Derby Diocesan Association of Church Bellringers Consultant's Report	Report DDACB 04/06
Church of St Michael & All Angels, Hathersage - Inspection of Bells	Issue Date 06/08/06

FIGURE 1
BELL CHAMBER

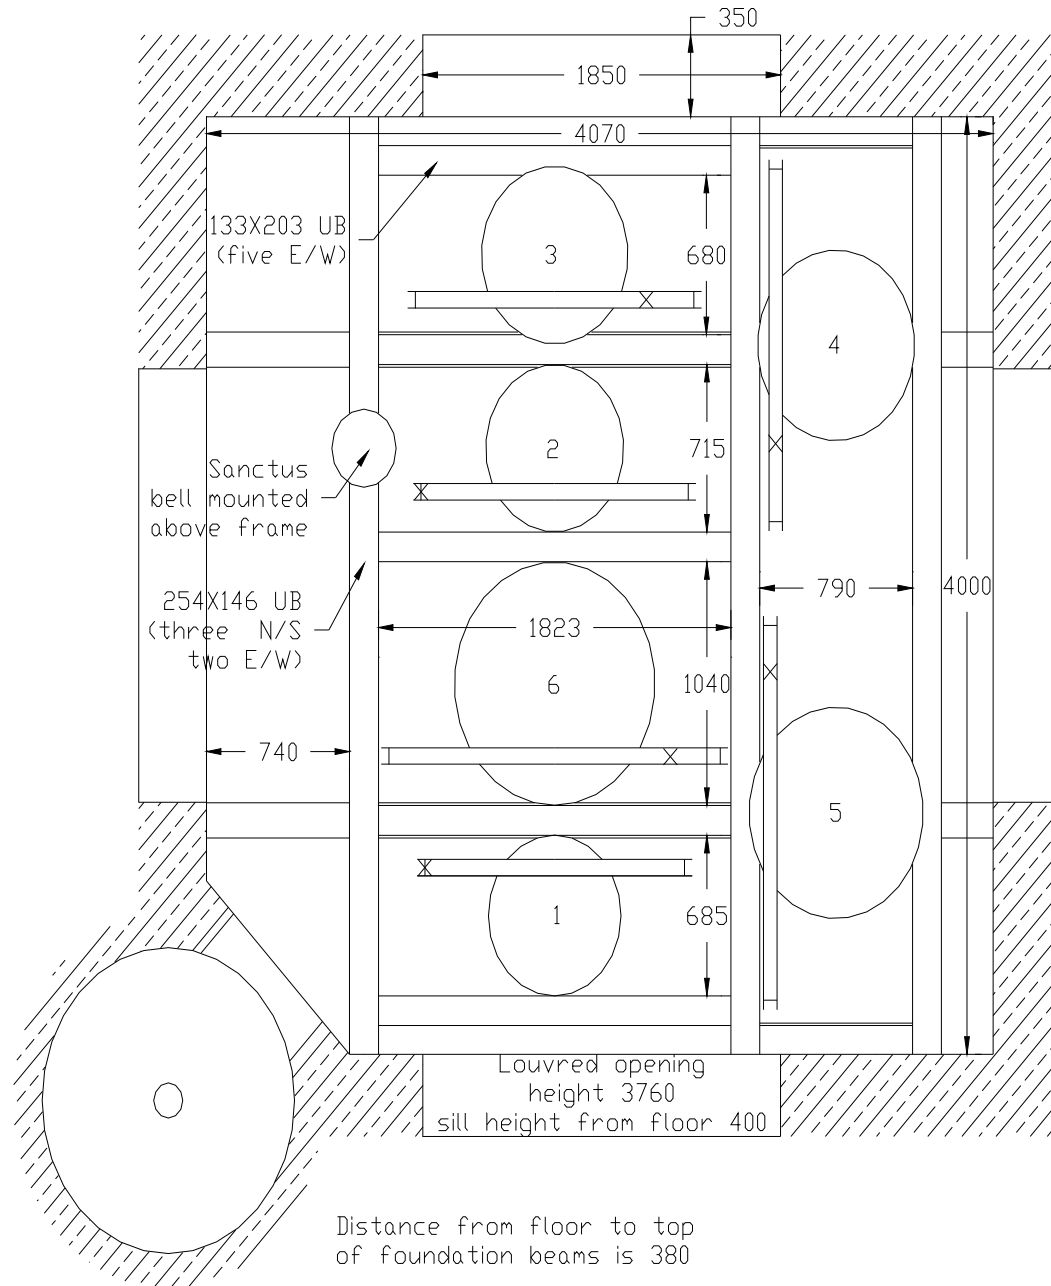
The area is illuminated by one floodlight and one incandescent bulb, which give adequate lighting for everyday use. On the North and South walls immediately above the apex of the louvres two cracks extending upwards were observed. There was some bird debris, the situation probably being made worse by the repair work that had been carried out on the South louvre to the supports and fitting of new slates. The wooden floor appeared sound and was fitted within the section of the foundation beams. Some thought had been given to soundproofing the louvres as when being rung full circle the open throat of the bells is above the lower level of the louvres.

11. Remove bird debris from bell chamber and complete repointing of the louvres.
12. During the next quinquennial inspection, seek the church architect's opinion on the cracks in the stonework on the North and South walls immediately above the apex of the louvres in the Bell Chamber.

FIGURE 2
CLOCK ROOM

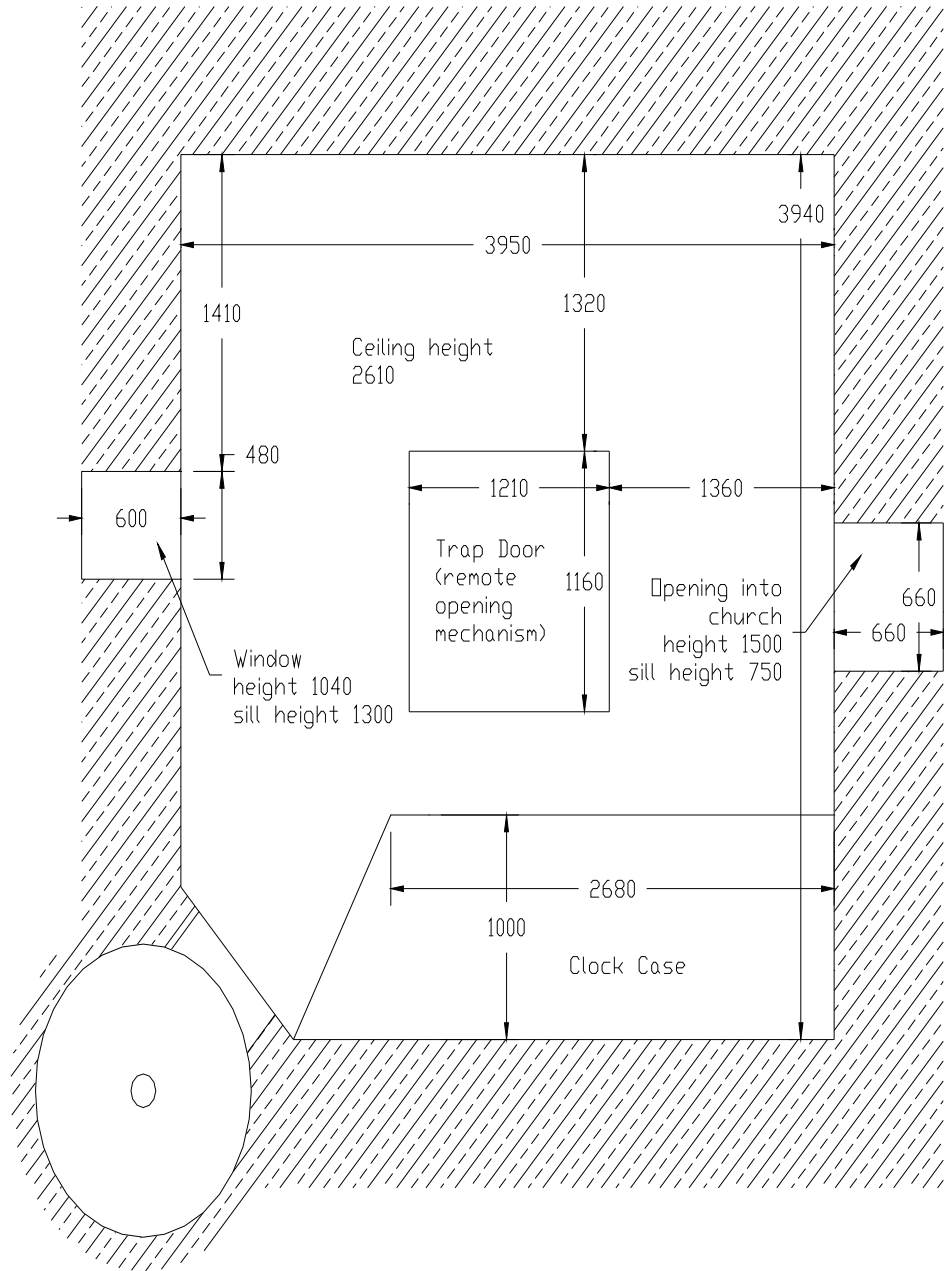
The clock room is reached by climbing 29 stone steps of the spiral staircase in the South West corner of the tower. The area almost square in section is illuminated by a single incandescent light bulb. A small window is fitted in the West wall and there is an opening into the church on the East Wall. The sill height to this opening is 0.75 metres and the wall thickness was measured at 660mm. Running down the entire length of the South wall is the wooden clock case. The floor of wooden construction contains a trap door measuring 1210mm

x 1160mm which can be raised and lowered from the Ringers' Gallery. The wooden ceiling is 2.610 metres above the floor. Running East - West are the lower sections of the two 'I' section foundation beams. All ends are keyed into the walls. Running East – West against the North Wall is another 'I' metal beam of smaller section which supports part of the wooden belfry floor.

FIGURE 3
RINGERS' GALLERY

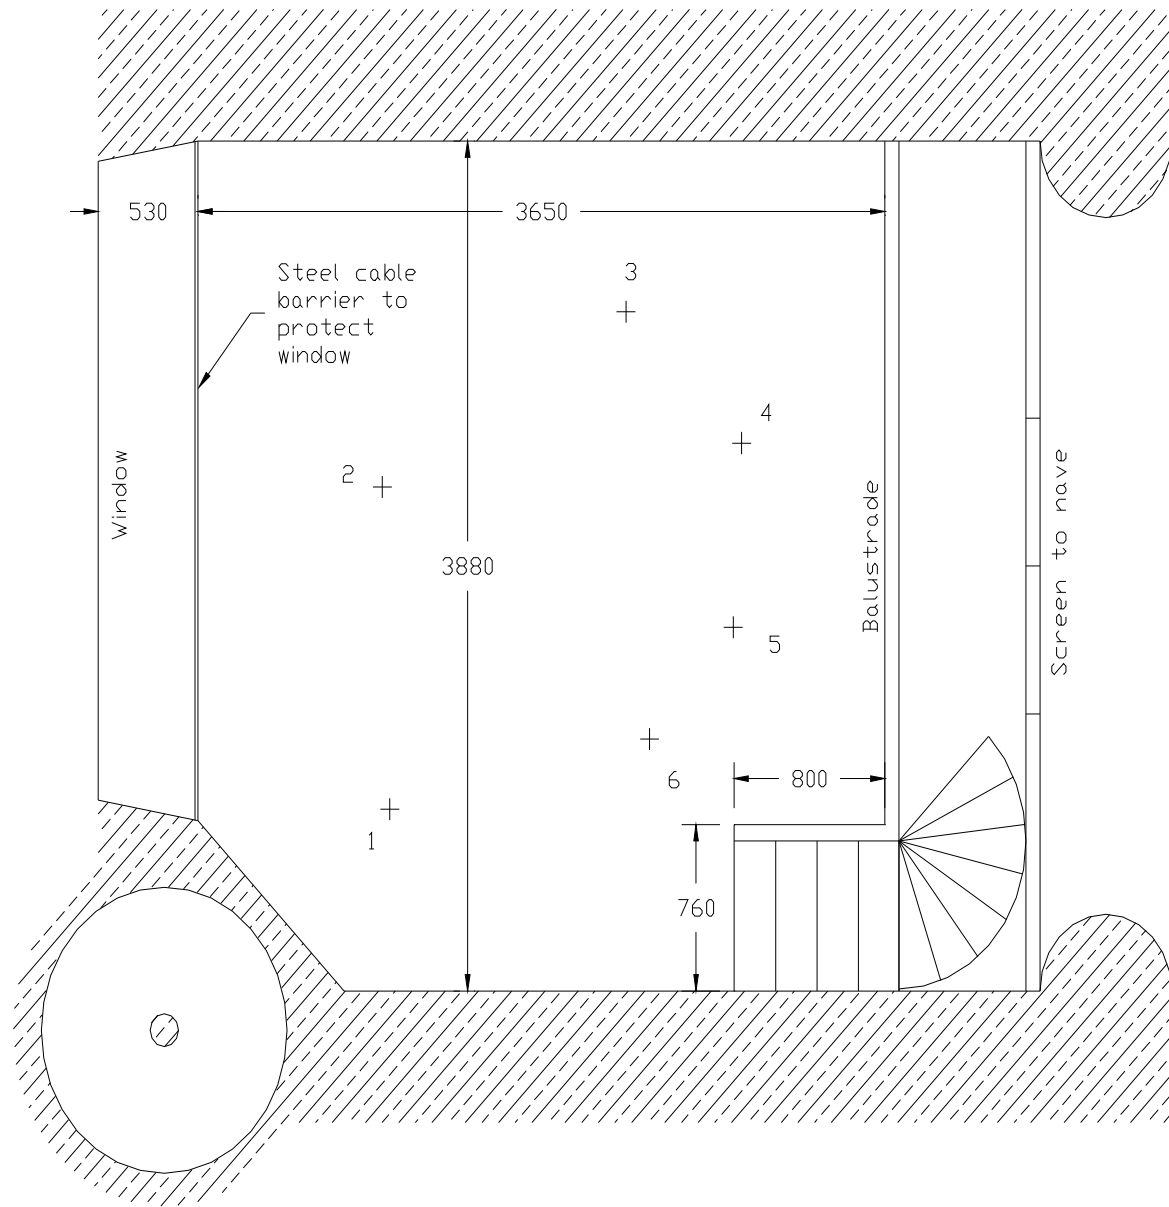
The ringers' gallery is reached by climbing the 11 steps of the metal fabricated spiral staircase. The area, almost square in section, is clean, carpeted and illuminated by four floodlights fitted high up in each corner. The lights in the South West and North West are at present working. The ones fitted in the South East and North East corners were not functional at the time of the inspection.

The six ropes fall in an acceptable circle and a rope guide rail is fitted 4.1 metres from the gallery floor level. The ceiling height was measured at 5.2 metres, located in which is a trapdoor which can be remotely opened by a rope and pulley system fitted on the South wall of the gallery. A large stained glass window is recessed into the West Wall. The floor of the Ringers' Gallery ends 530 mm. short of the window supports and this potentially dangerous gap is well protected by steel cable wires that run across the entire width of the window wall. The sanctus bell rope falls between the steel cable barrier and the window to the ground floor area.

10. The fault in the floodlights fitted in the South East and North East corners of the Ringers' Gallery should be rectified. If it can happen to these two lights there is no reason why it cannot happen to the other two. With the dark evenings approaching the natural light from the window will be reduced and any natural light from the nave of the church will be minimal.
